# Learmonth Terrace (Dean Park Crescent) Walking and Cycling Improvements

Consultation Summary Report  
April 2017

Figure 1 High level proposal for the junction

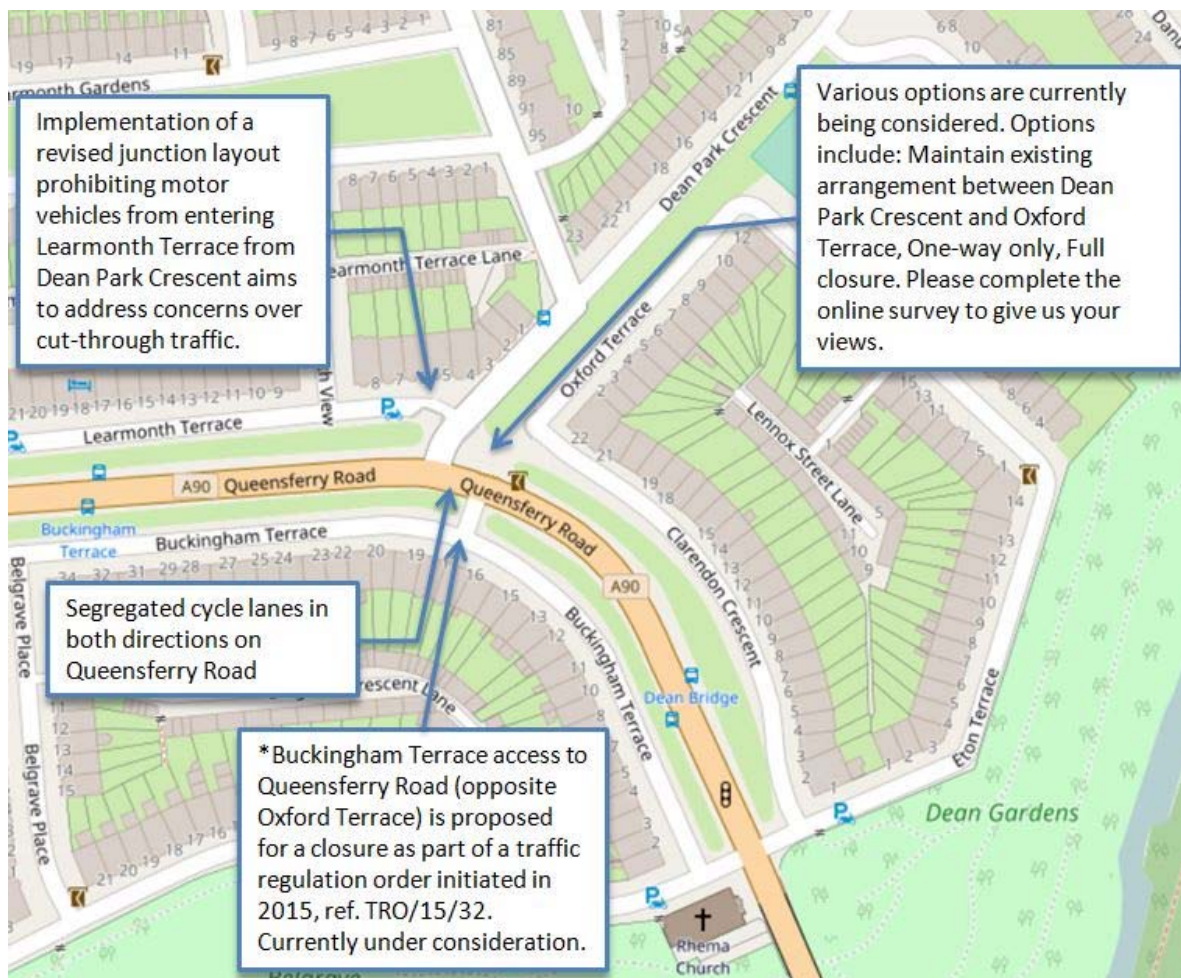
The short section of road from Comely Bank Avenue to Queensferry Road is part of Learmonth Terrace (i.e. Nos 1-4 as shown on the street plan in the consultation document). Dean Park Crescent stops at its junction with Comely Bank Avenue (i.e. at No 23).

As a local resident and regular walker to/from the West End, I would strongly favour the full closure of the vehicle access between Learmonth Terrace and Oxford Terrace, thereby enhancing the potential benefits to pedestrians and cyclists.

The proposal to close the direct access from Oxford Terrace to Queensferry Road is also to be commended, given this junction's close proximity to the Learmonth Terrace / Queensferry Road junction and the conflicting turning movements involved.

The issue could be addressed either by (a) prohibiting vehicles from entering the western section of Learmonth Terrace (i.e. west of No 4) from the short eastern section of Learmonth Terrace (as indicated on the street plan in the consultation document), or by (b) placing a restriction on Learmonth Terrace to the west of its junction with Learmonth View.
